FORREST HOUSE

BLOCK 11 SECTION 7 FORREST

DRAWING NO.	TITLE
WA000	PLAN - LOCATION & DRAWING SCHEDULE
WA004	PLAN - DEMOLITION
WA005	PLAN - SITE
WA007	SOFT LANDSCAPE ANALYSIS
WA008	SHADOW DIAGRAMS
WA009	SHADOW DIAGRAMS
WA010	SHADOW DIAGRAMS
WA011	PLAN - AREA GFA
WA011	PLAN - BASEMENT
WA102	PLAN - GROUND FLOOR
WA103	PLAN - FIRST FLOOR
WA104	PLAN - ROOF
WA200	STREETSCAPE ELEVATION
WA201	ELEVATIONS
WA202	ELEVATIONS
WA300	SECTIONS
WA900	STREET PERSPECTIVES

4 21st DECEMBER 9am - PROPOSED

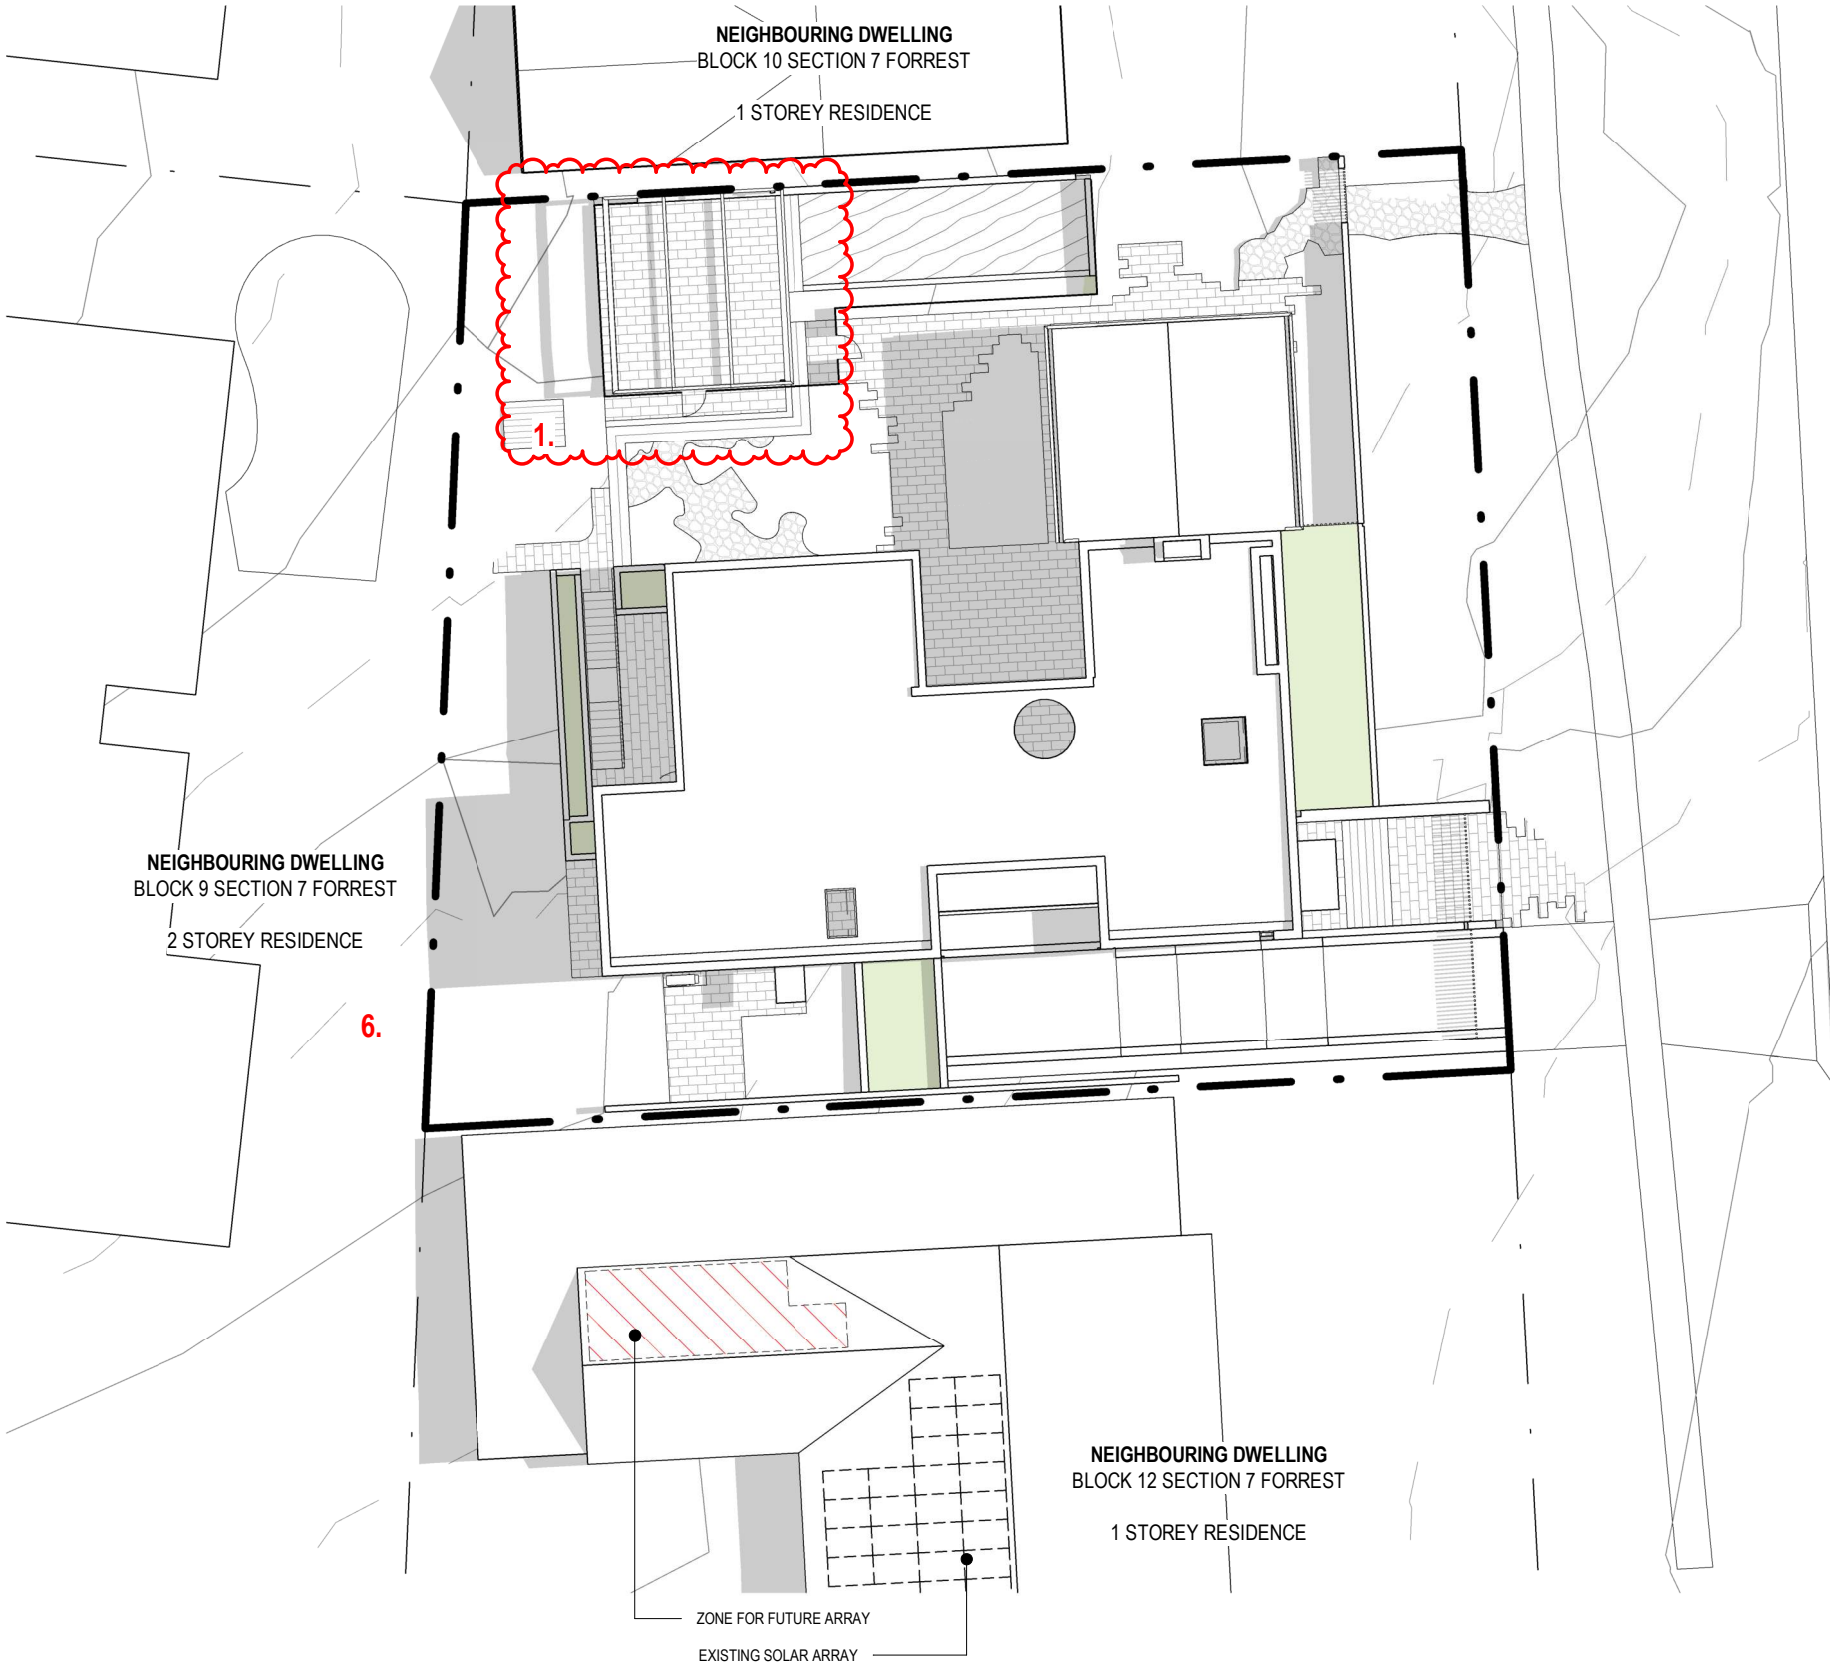
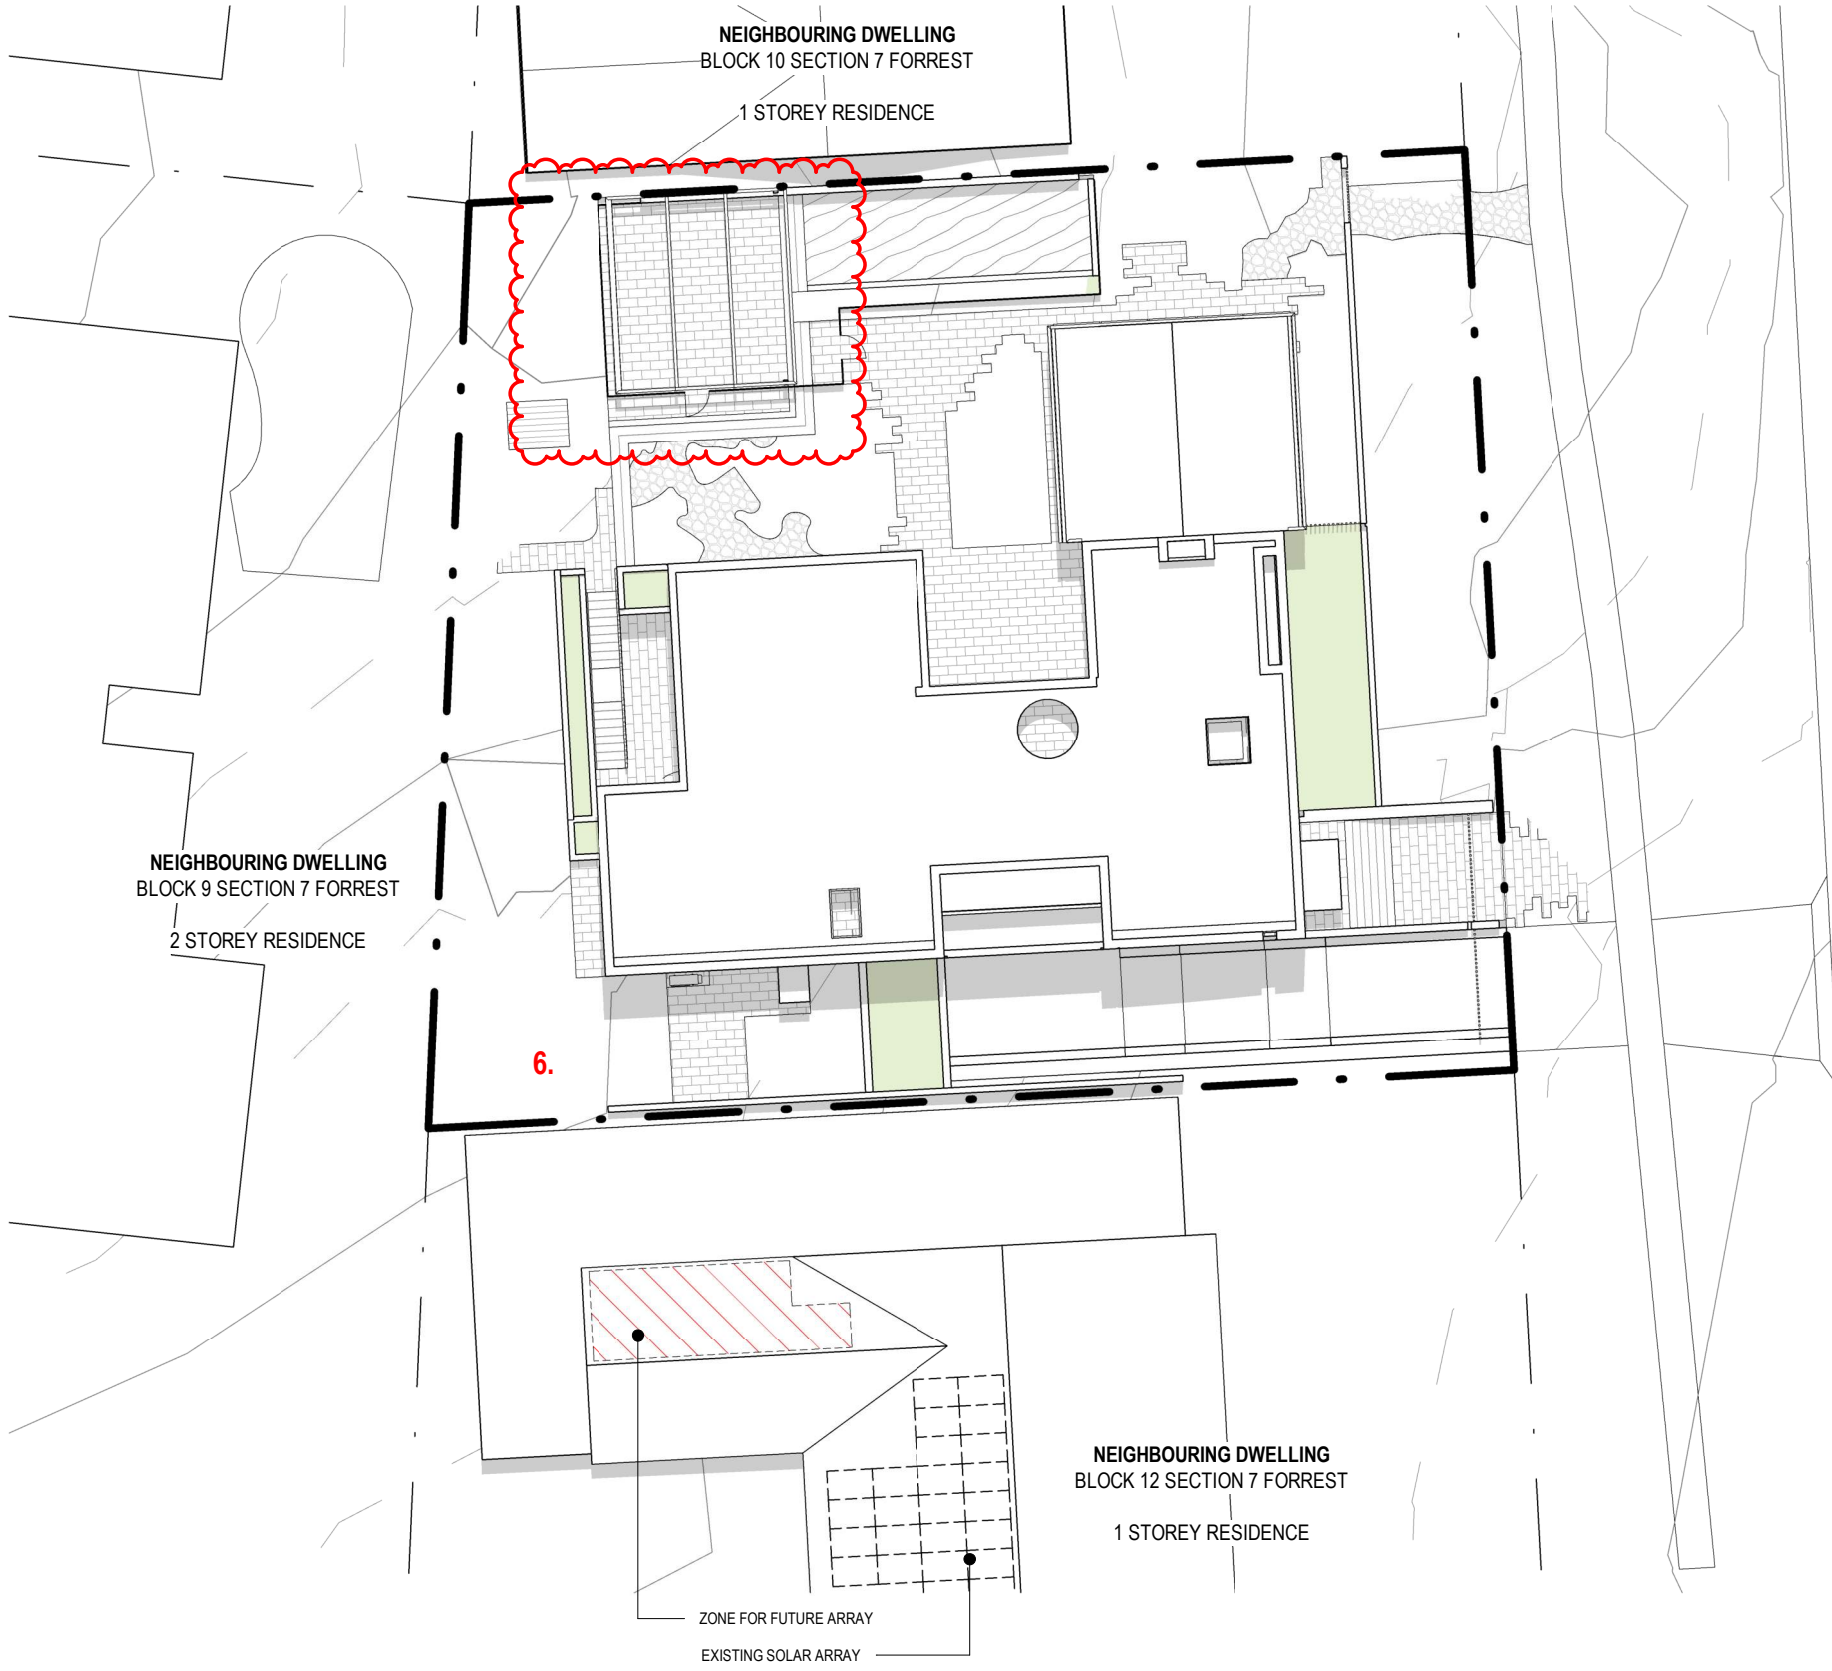
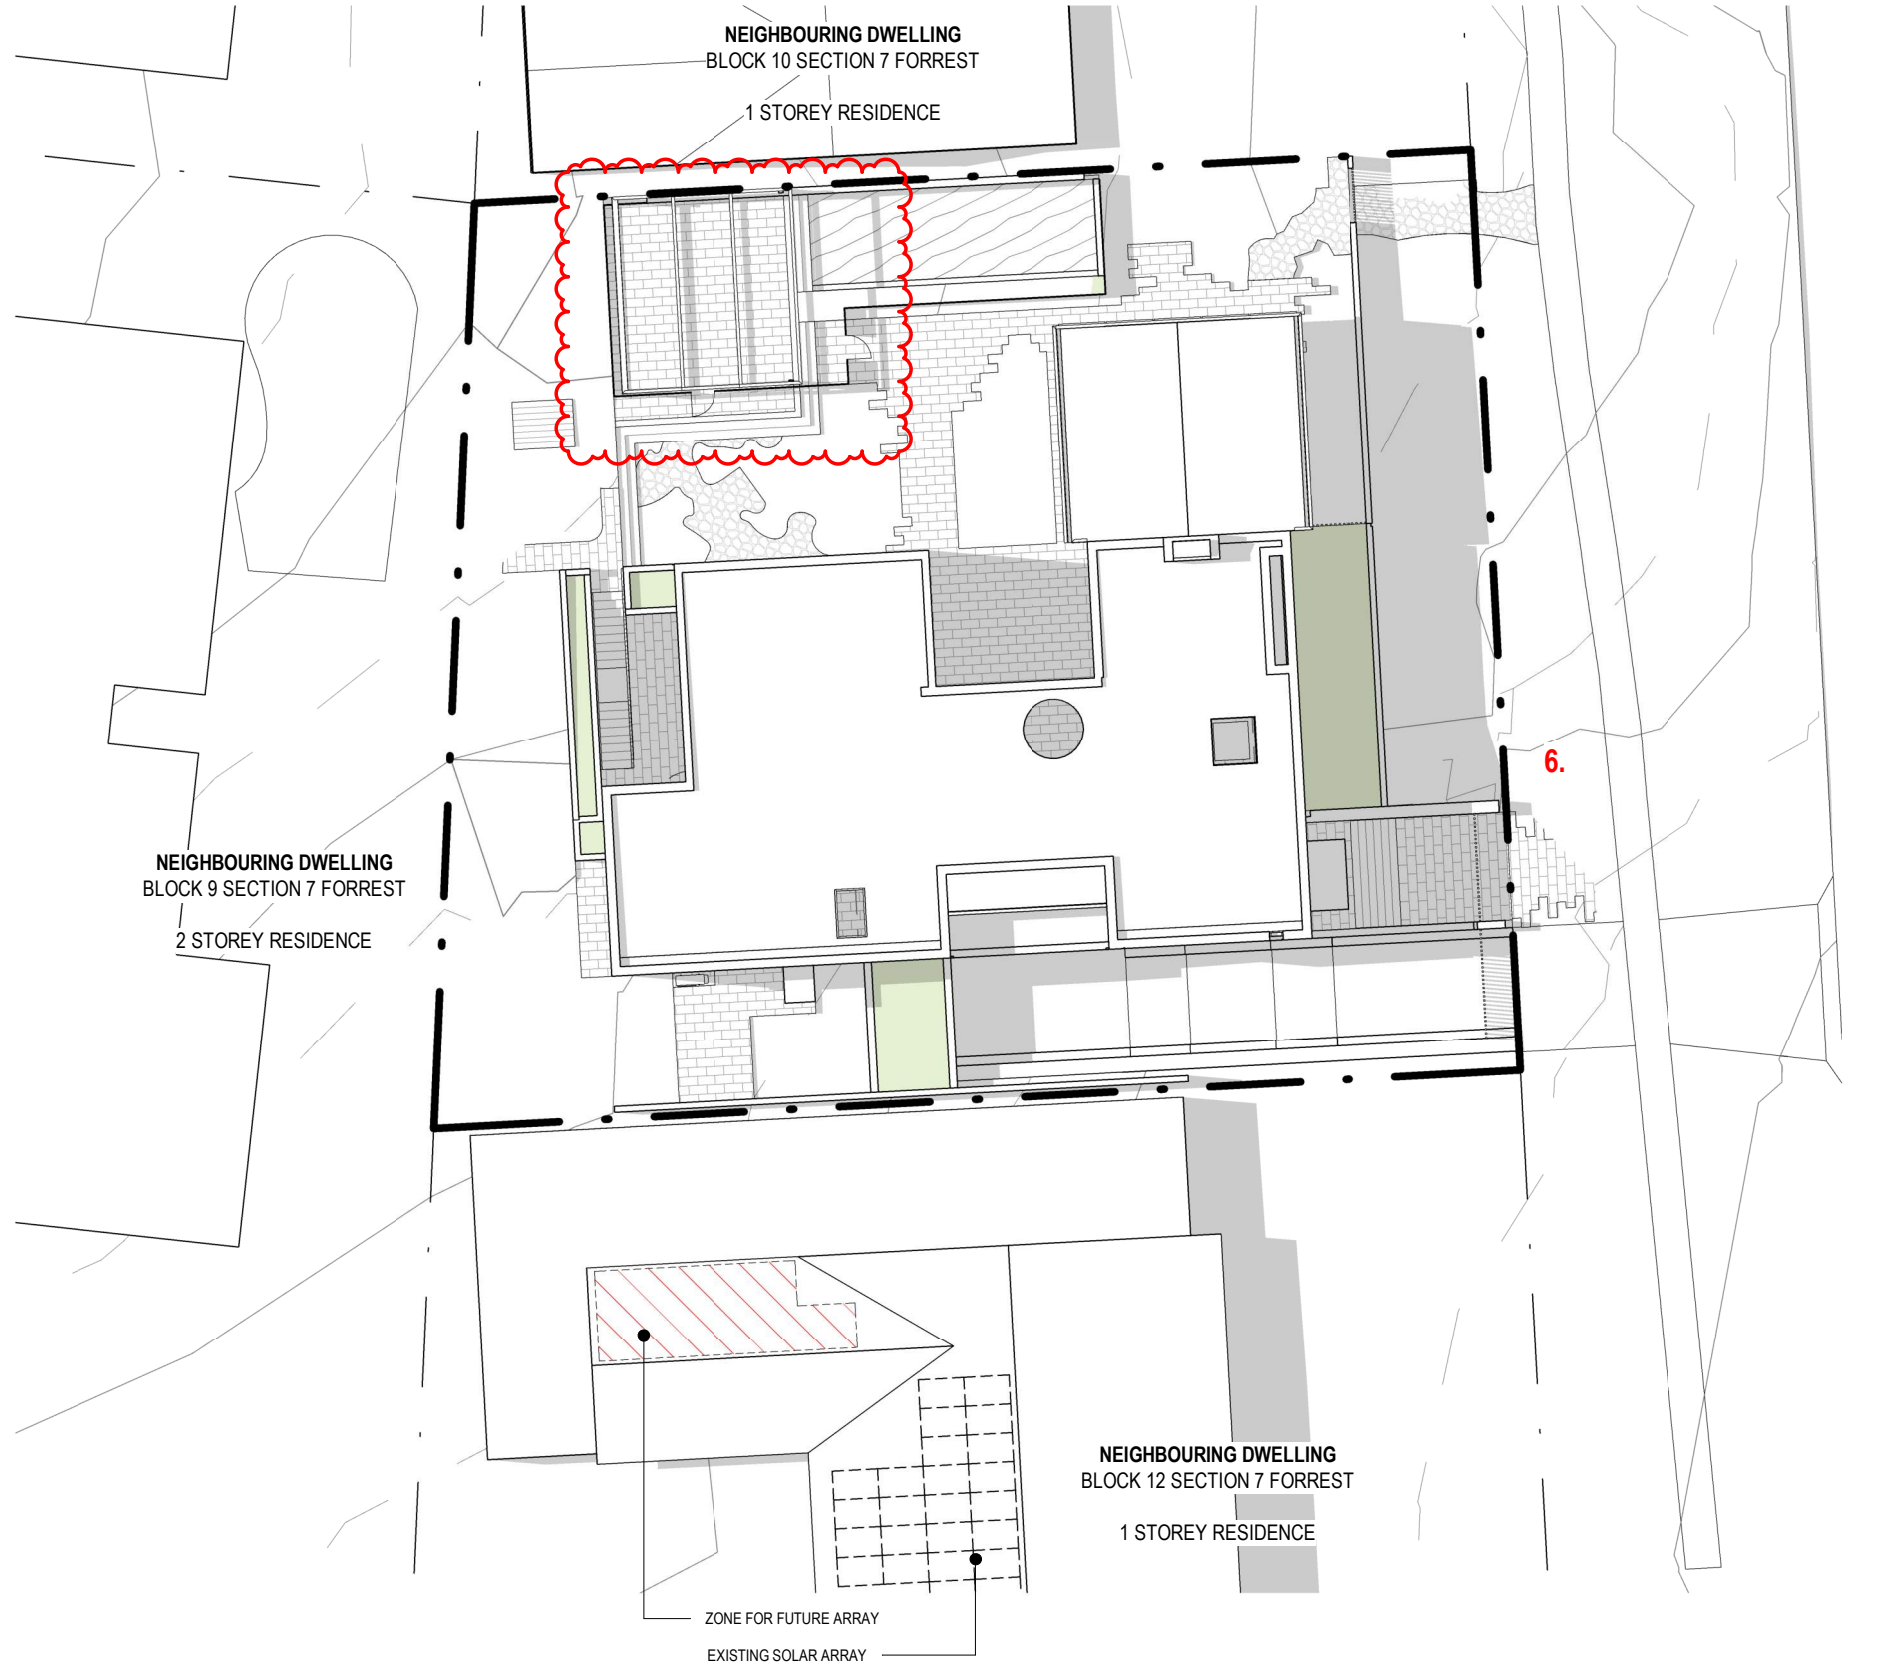
- EASTERN WALLS MOVED 240mm WEST TO SETBACK LINE.
- WESTERN WALLS MOVED 500mm EAST.
- FACADE ARTICULATION WALL REMOVED.
- POOL PAVILION WALLS REMOVED. AREA NOW AN UNENCLOSED COVERED AREA.
- SOFT LANDSCAPING AREA INCREASED, GFA DECREASED.
- SHADOW EXTENT REDUCED AS A RESULT OF THE BUILDING FOOTPRINT DECREASING
- STUDY AND DINING ROOMS INCREASED IN DEPTH. MASTER BED PLANTER REMOVED.
- SOUTHERN LANDSCAPE ALTERED FOR GREATER VISUAL PRIVACY.
  - FEATURE TREE CENTRED TO MASK VIEWS TO/FROM STAIR
  - ADDITIONAL PLANTING ADDED TO BOUNDARY WALL
  - ADDITIONAL LARGER PLANTING ADDED TO KITCHEN PLANTER (REFER LANDSCAPE DOCUMENTS)
